System Impact Assessment Report

CAA ID No. 2005 - 207

Applicant: Five Nations Energy Inc.

***Project: Energize Second Transformers at Fort Albany
TS and Attawapiskat TS***

Figure 3. Proposed Connection of Second Transformers at Fort Albany and Attawapiskat

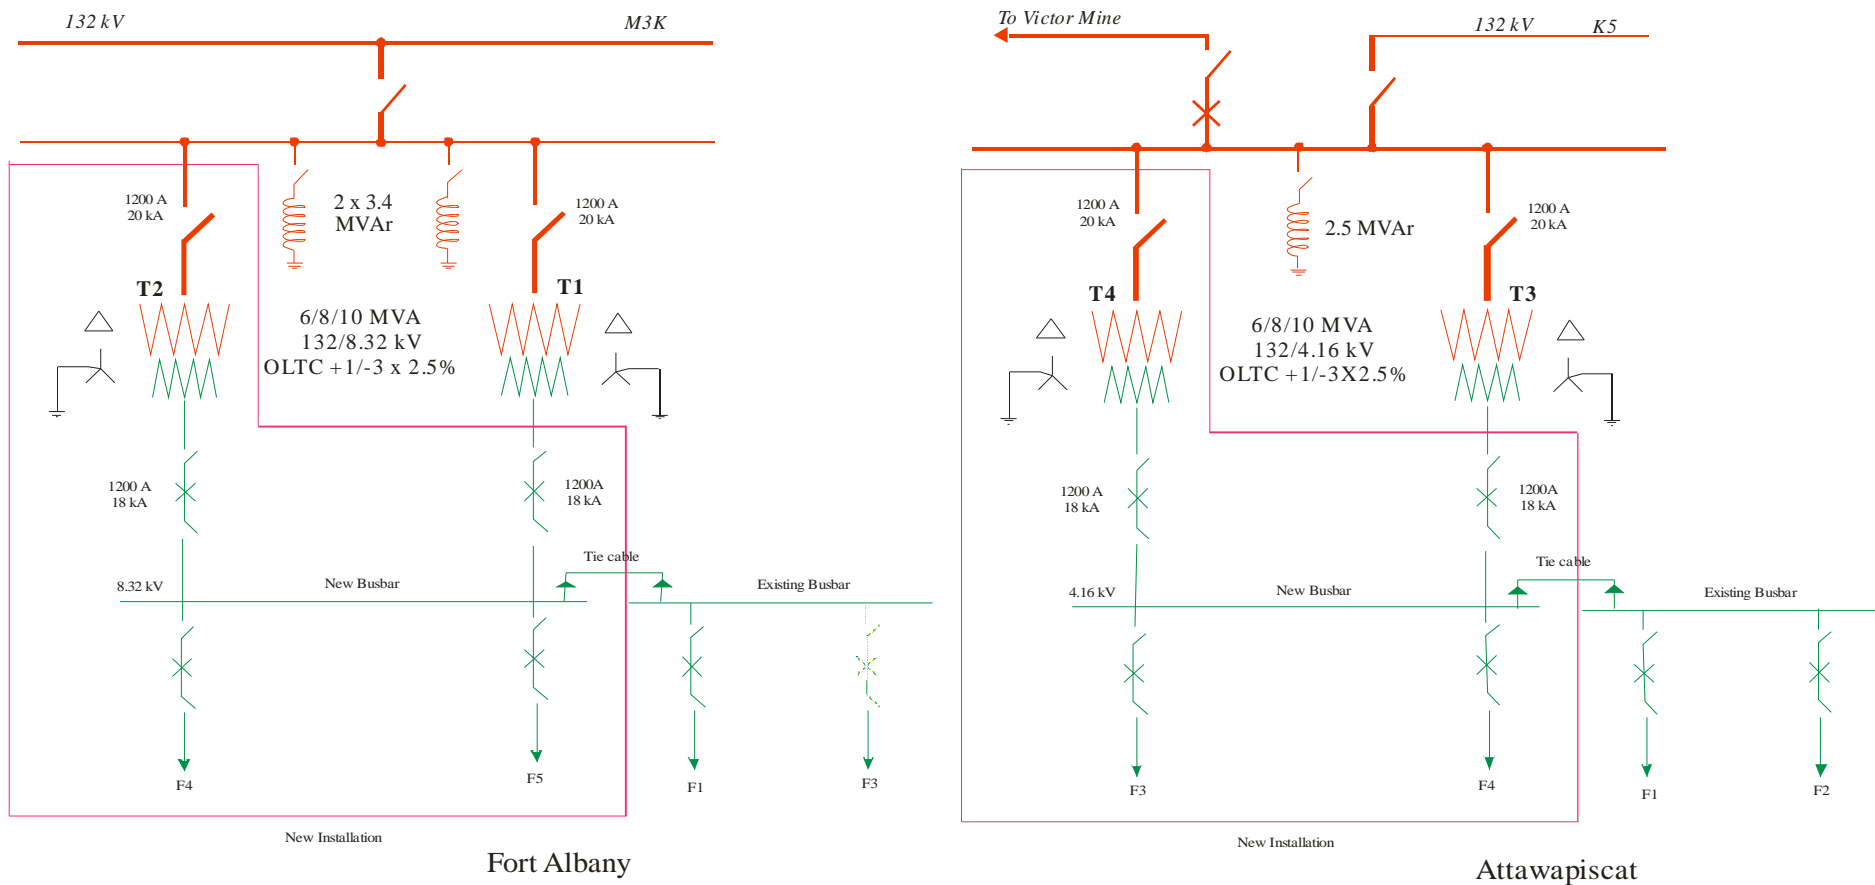
The Market Rules (Chapter 5 section 10.4) require that each distributor and connected wholesale customer, in conjunction with the relevant transmitter, make arrangements to enable the automatic disconnection of up to 35% of its peak demand for conditions of system under-frequency. To meet this requirement an underfrequency load shedding (UFLS) scheme must be installed at the station. The single line diagram provided by the applicant does not show the presence of the UFLS scheme.

A full description of the connection arrangement of the proposed connections is included in section 2.1 of this report. It should be noted that 115 kV circuit switchers proposed for installation do not meet the interrupting capability recommended by the Transmission System Code.

The Fault Levels specified in Appendix 2, Transmission System Connection Point Performance Standards, indicate 50 kA for a nominal voltage of 115 kV. The interrupting capability of the new switchers is 20 kA which is below 50 kA as specified in Transmission System Code.

The Connection Applicant is required to apply for the extension of the existing exemption. If the extension is not granted, FNEI should install UFLS at the stations to meet the Market Rules requirements.

It can be seen that the fault levels at Fort Albany substation and Attawapiskat substation are far below the interrupting capability of 20 kA of the new switchers. In addition, there is no plan for system improvement or reconfiguration in FNEI's system in the future. Therefore, the new switchers with the interrupting capability of 20 kA are adequate.
